From: City of Ann Arbor Transportation Commission
Subject: FW: Bicycle Parking Requirements

From: Adam Goodman <XXXXXXXXXX>
Sent: Thursday, July 7, 2022 10:30 PM
To: Planning <Planning@a2gov.org>
Cc: City of Ann Arbor Transportation Commission <TransportationCommission@a2gov.org>
Subject: Bicycle Parking Requirements

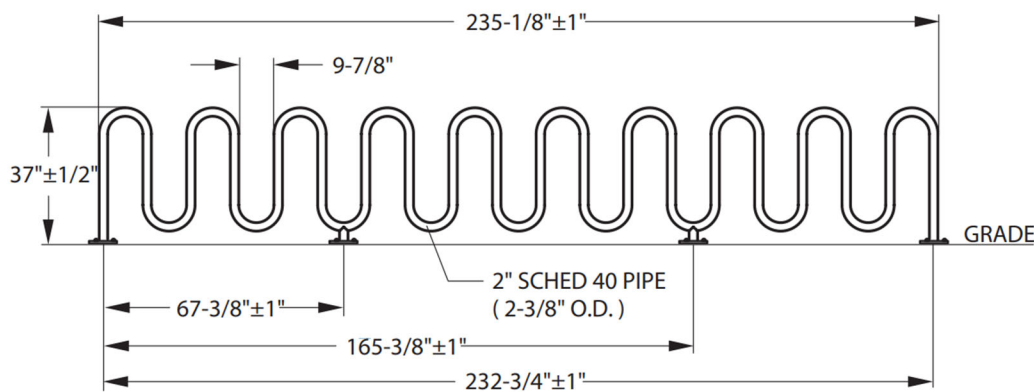
Now, for one example: a 2016 site plan for the Maple Village shopping center's parking lot improvements (project SP15-052 in etrakit - <https://etrakit.a2gov.org/etrakit/Search/project.aspx?activityNo=SP15-052>) promised to include the (required) 88 bicycle parking spaces using 4 "Belson Model H36-21-G-SF" bike racks dispersed through the development, e.g.:

This rack claims to have a capacity for 21 bikes. Some very simple math would show, then, that it does not meet the city's existing standards, which again state: "One Bicycle Parking Space shall consist of a space not less than **two feet wide** by six feet long". In this rack, bicycle parking spaces are - interpreting measurements generously - about 1 foot wide, not 2.

Maple Village is just one example. I've seen several other relatively-recent developments also use this sort of bike rack design. So, as I said at the top, I would ask that the city apply its existing standards more rigorously on future plan reviews.
